**CITY OF WILDWOOD'S
PLANNING AND ZONING COMMISSION**

September 19, 2016 - Monday

- a. P.Z. 6-16 Auburn Ridge, Fischer And Frichtel Custom Homes, 695 Trade Center Boulevard, Chesterfield, Missouri, 63005

1. A Recommendation Report Of The Site Plan Subcommittee Of The Planning And Zoning Commission Regarding P.Z. 12 And 13-15 The Villages At Bright Leaf

Auburn Ridge
 Wilwood, Missouri
 Preliminary Development Plan
 Sight Distance Study

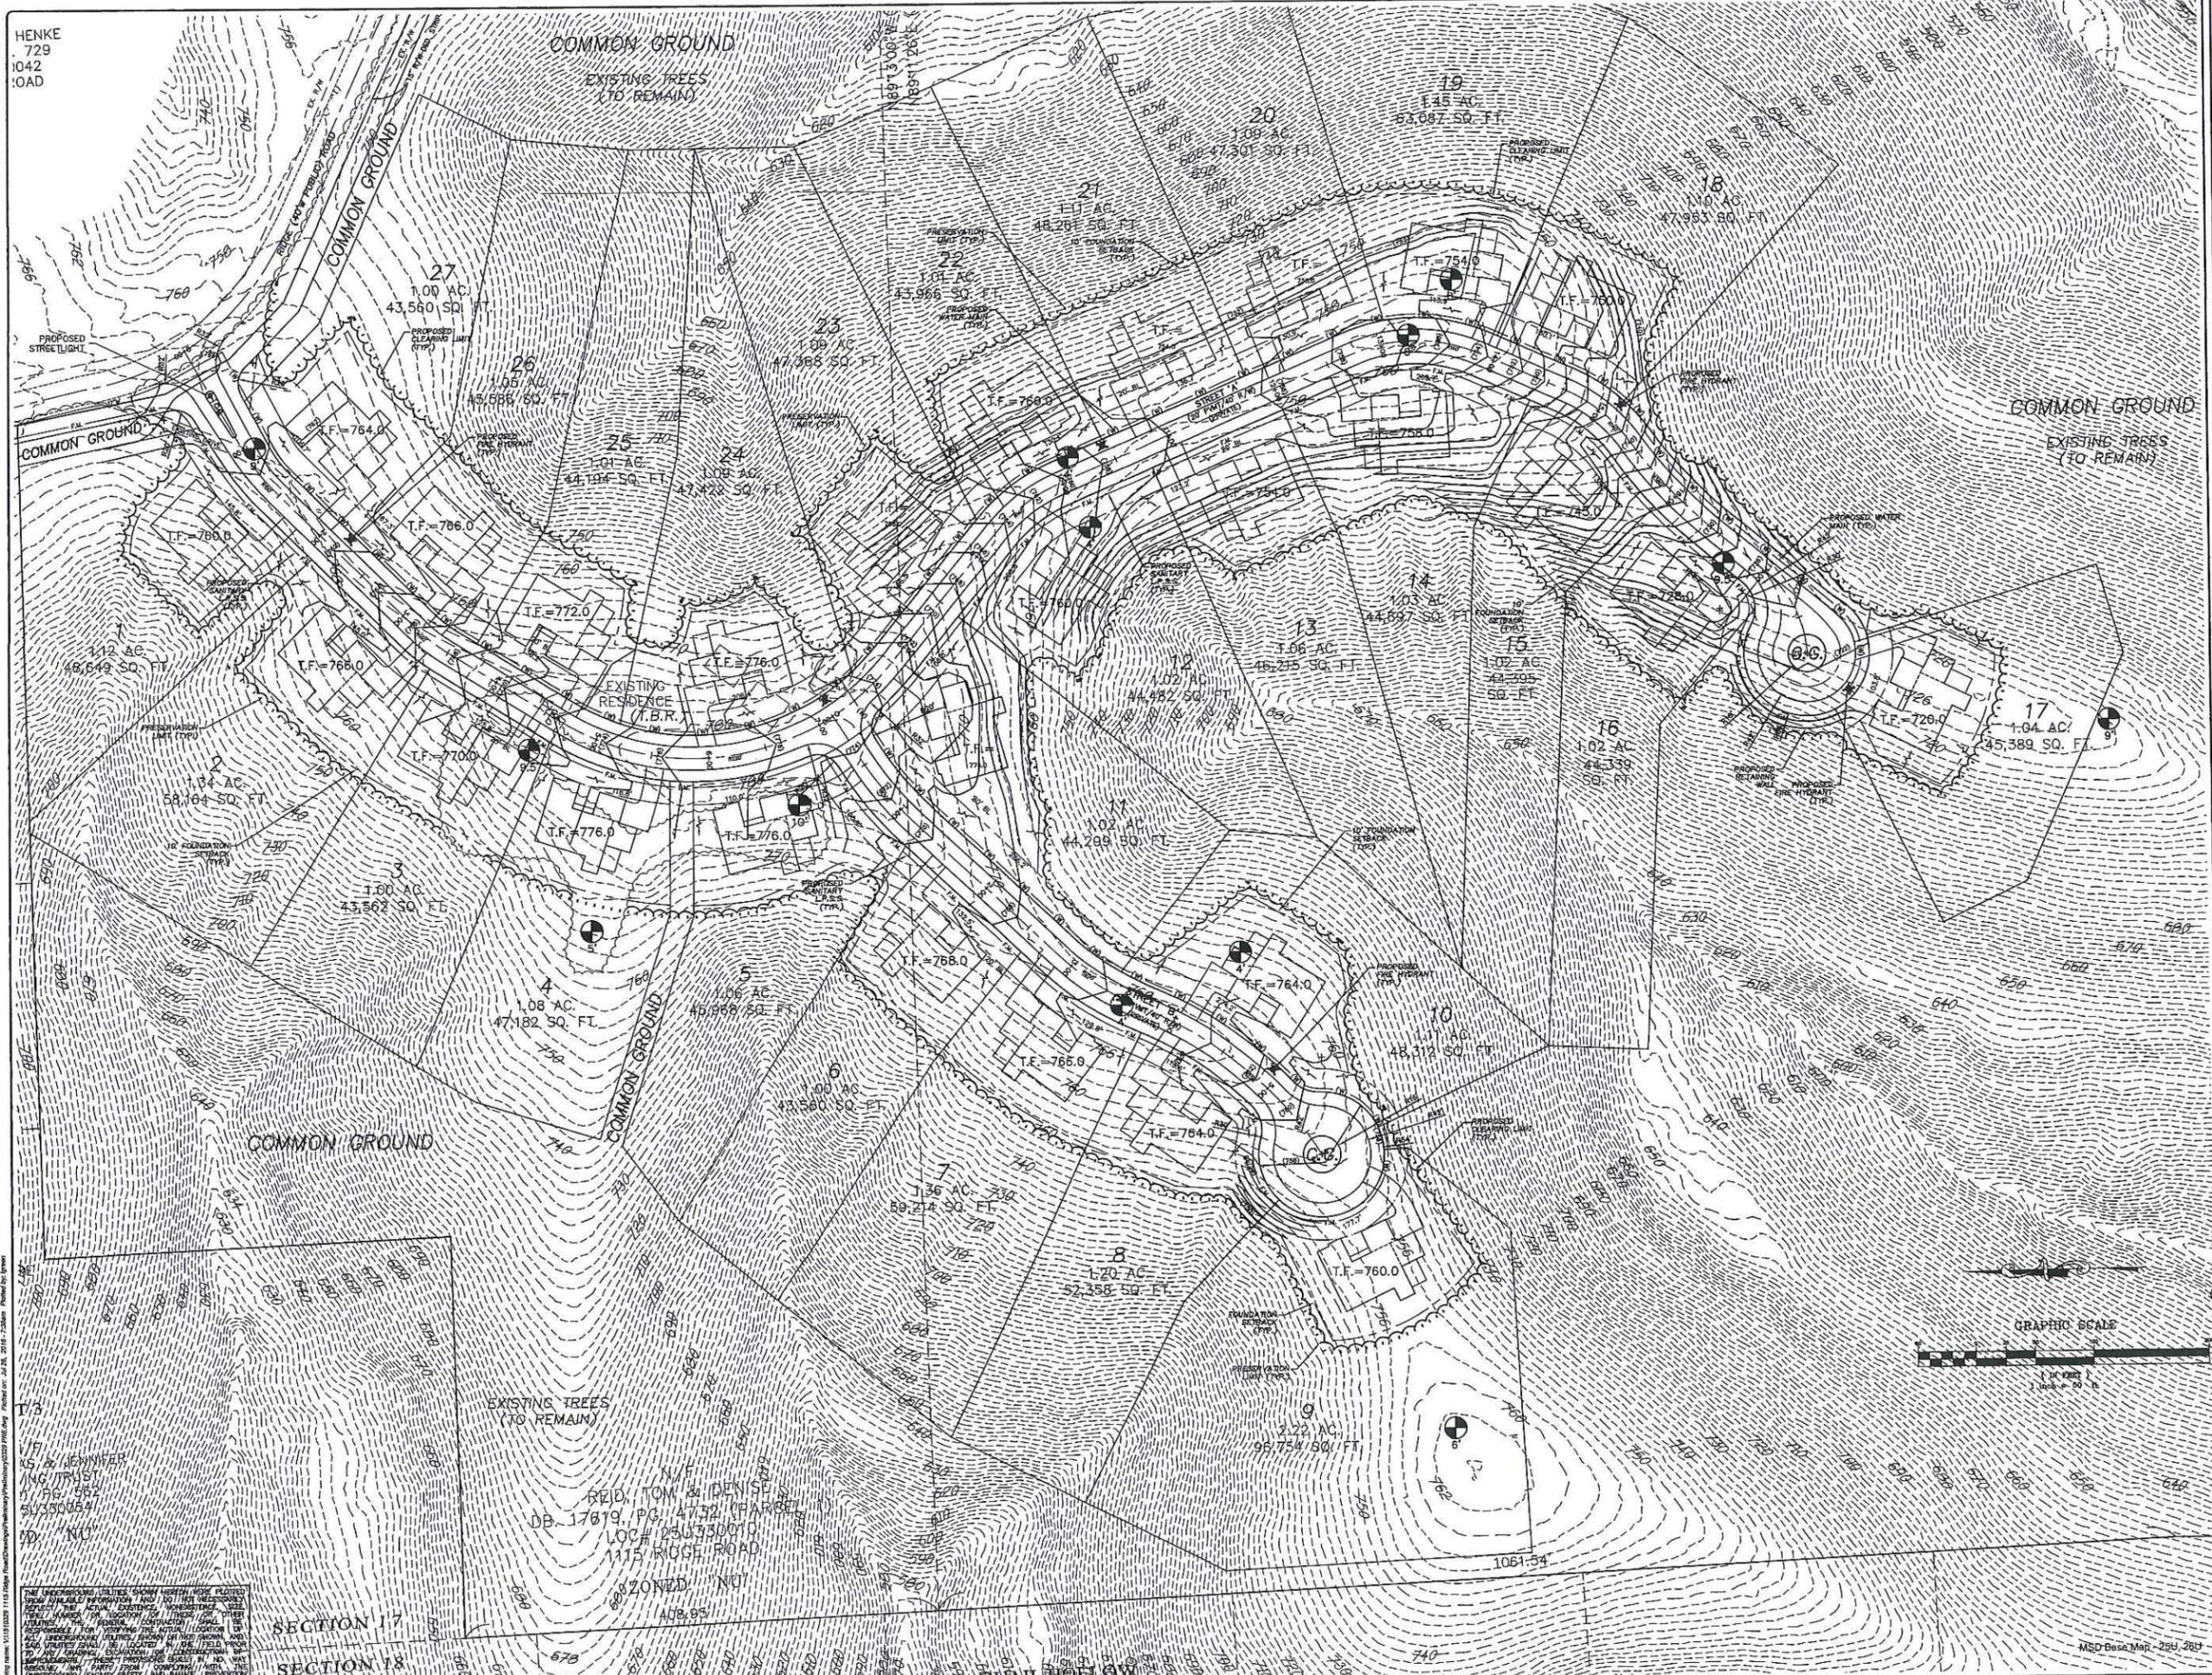
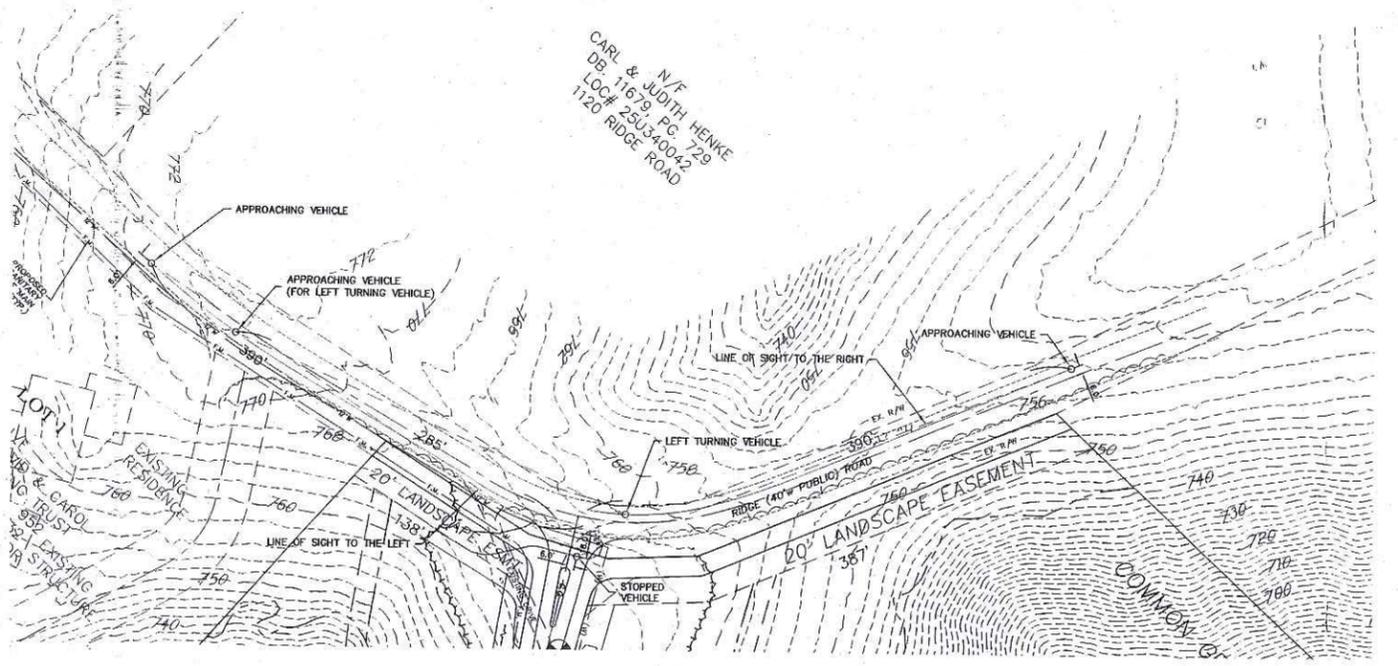
14. The Department of Public Works has expressed a concern about the sight distance at Ridge Road and its intersection with the planned private street. Please provide more data regarding the sight distance analysis that is shown on Sheet 4.1 of the submittal package.
